# FINAL DRAFT MINUTES

## June 18, 2020 Standards Committee Meeting

RE: Minutes from the June 18, 2020 Standards Committee Meeting

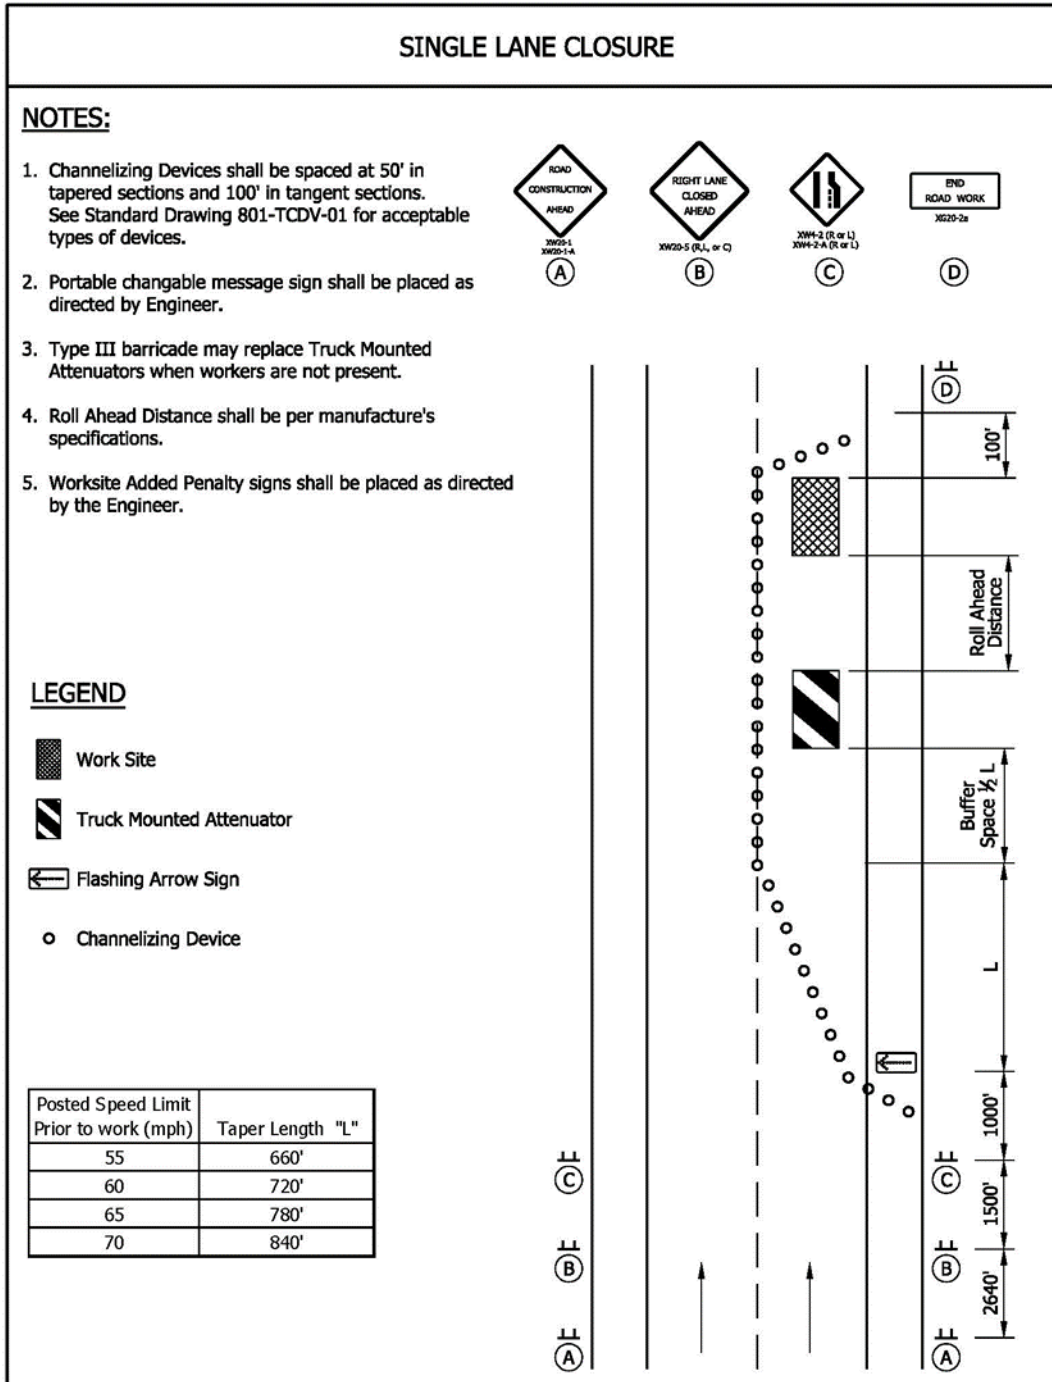
Mr. Bruno confirmed that he has reviewed this USP on a regular basis and provided further clarification. As for the RPD, the details shown illustrate the most current standards and practices. Mr. Reilman inquired about the speeds shown and Mr. Bruno and Ms. Smutzer confirmed that those speeds are correct. Ms. Smutzer proposed having language that the equipment is approved for use if the eligibility letter is not available. Ms. Smutzer also asked if Work Zone Safety has provided any input. Mr. Boruff offered that we could specify that all equipment shall be in proper working condition, of which that language already exist in the special provision. Mr. Kachler offered that he could find no specific material requirements in ATTSSA for TMAs.
